April 12, 2017

To: Menlo Park City Council

Subject: Bike Project Field Trial Must Validate Bike Safety Claims

Potential Safety Trouble Spots – Map View

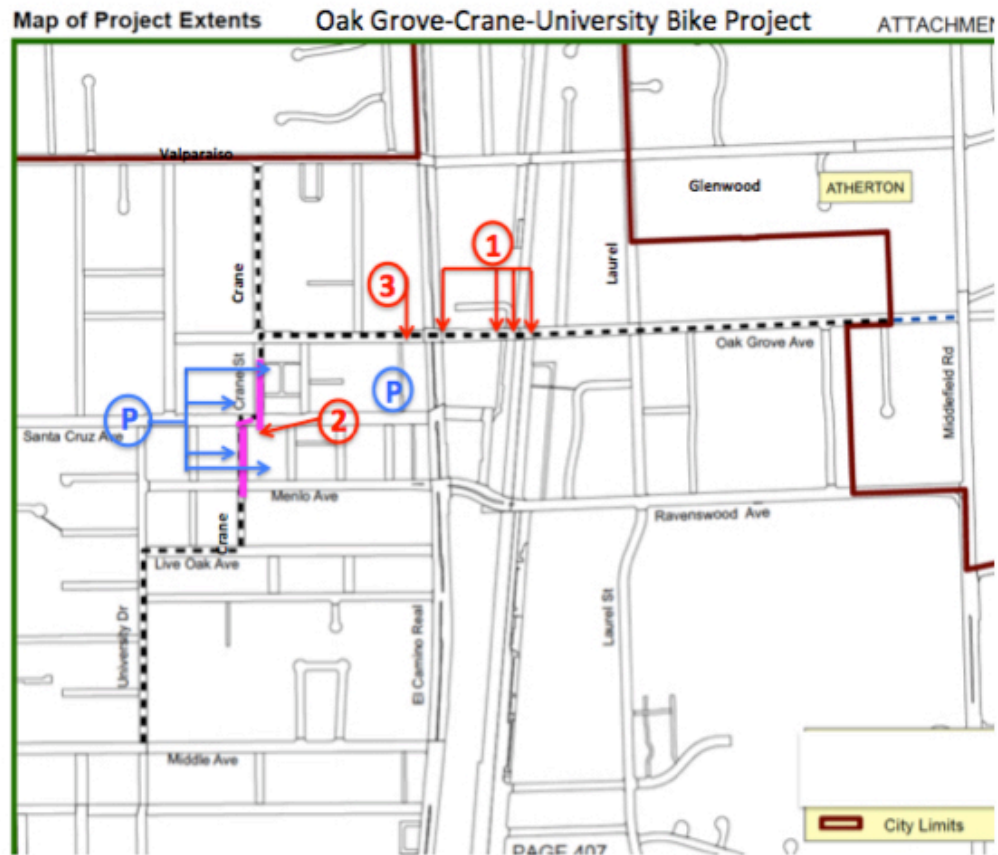
1. The eastbound bike lane on **Oak Grove** will pass parked vehicles, and while there will be an eighteen inch wide buffer, motorists will still need to cross bike lanes whenever they enter or exit a street parking space.

2. Bicyclists will still share vehicle lanes on the two narrow and busy sections of **Crane** between Menlo Avenue and Oak Grove, and Crane is usually lined with parked cars. Many bicyclists do not understand that the street markings (“sharrows”) are installed primarily to encourage them to ride in the middle of the lane ride where they can avoid opening doors. Unfortunately, many motorists and bicyclists do not understand this fact and bicyclists generally do not like to “take the lane” and impede faster vehicles.

3. Three public parking plazas and six busy entrances and exits exist on **Crane** between Santa Cruz and Oak Grove. Vehicles will frequently cross paths with bicyclists and visibility is poor. How will bike-vehicle conflicts be minimized?

4. The dramatic redesign of the **Crane-Santa Cruz-Crane intersections** will create a challenging environment for both motorists and bicyclists, especially given the number of distractions at this location and the likely impatience of motorist who will need to stop at two new additional stop signs on Santa Cruz. Also, the California legislature is now considering [A.B. 1103](#), which in its current form would authorize “a person operating a bicycle approaching a stop sign, after slowing to a reasonable speed and yielding the right-of-way, to cautiously make a turn or proceed through the intersection without stopping, unless safety considerations require

5. The creation of the **Garwood Way** extension at Station 1300 means there will be four busy intersections in a short section of Oak Grove (at El Camino, Merrill, Garwood Way and Alma) where bikes and vehicles will constantly cross paths. Are new bike and/or vehicle traffic controls needed? Where?
